SUBJECT: COMANCHE PEAK NUCLEAR POWER PLANT, UNITS 3 AND 4
DOCKET NUMBERS 52-034 AND 52-035
COMBINED LICENSE APPLICATION PART 1, UPDATE TRACKING REPORT
REVISION 0

Update Tracking Report

Revision 0

**FIGURE 1.2-1
Simplified Ownership Diagram**

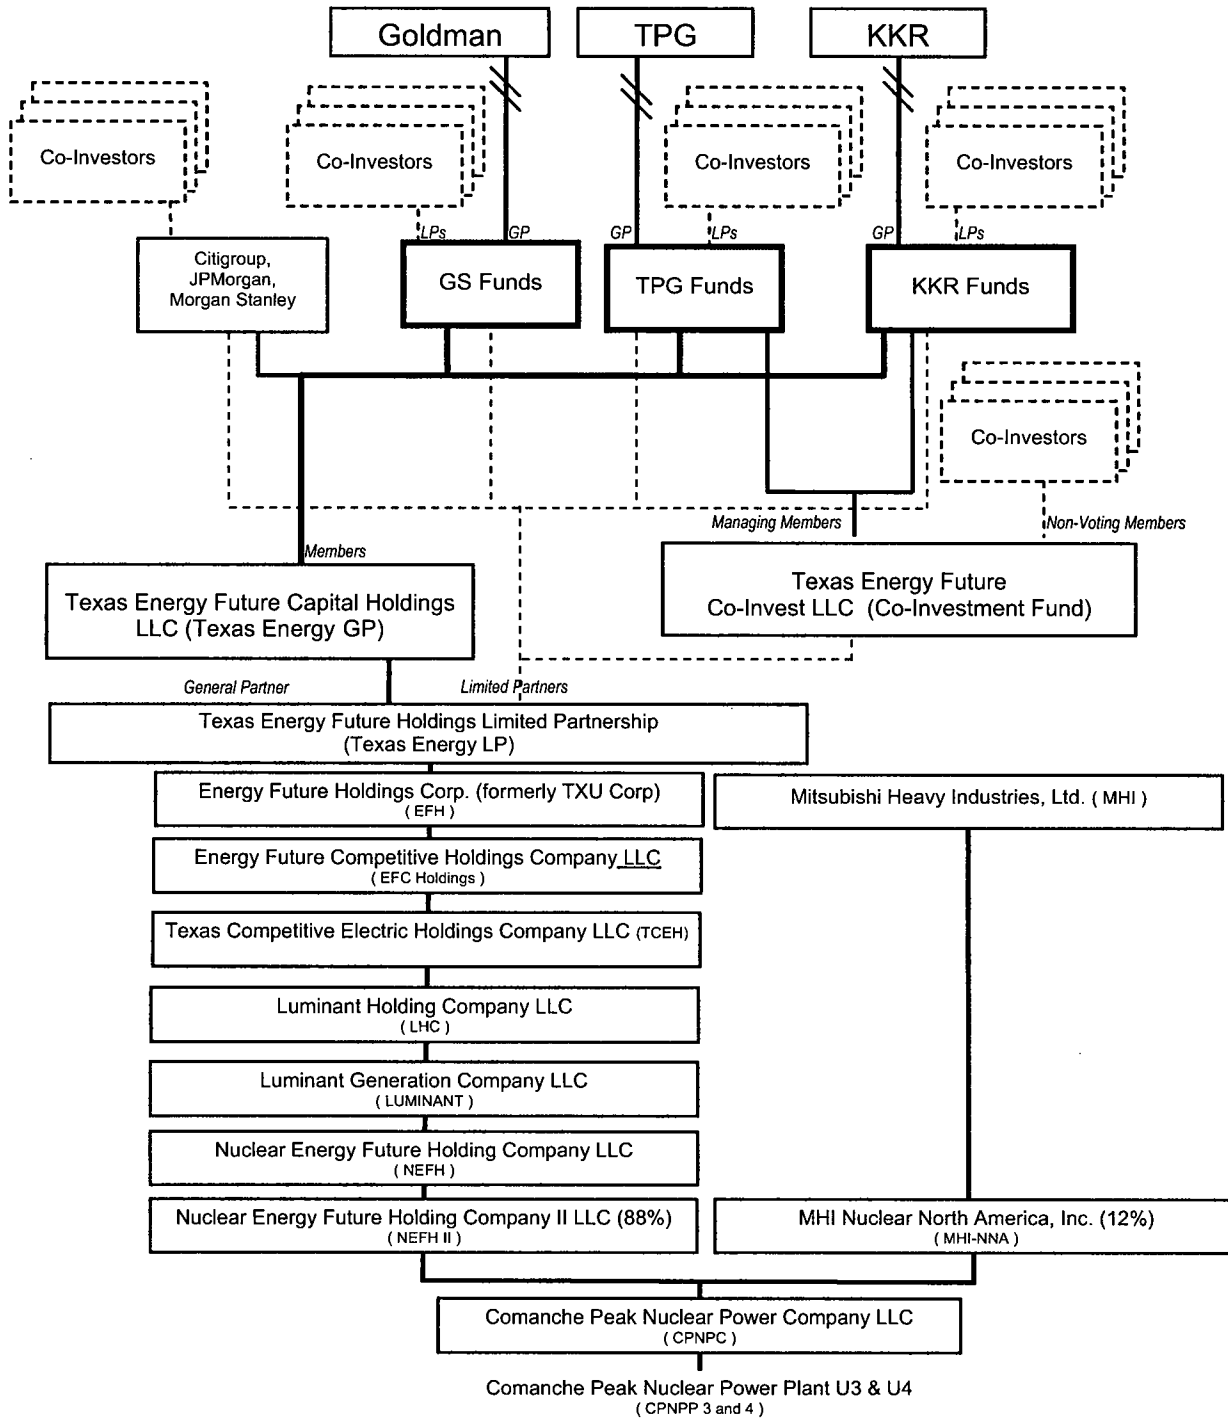
Change ID No.	Section	FSAR Rev. 3 Page	Reason for change	Change Summary	Rev. of FSAR T/R
CTS-01540	1.2.2	14	Organization update and editorial	Changed the address. Added "and" between MHI and MHI Nuclear North America.	0
CTS-01540	Figure 1.2-1	22	Corporate change	Updated name of Energy Future Competitive Holdings Company LLC	0
CTS-01540	Figure 1.2-2	23	Corporate change	Updated name of Energy Future Competitive Holdings Company LLC	0
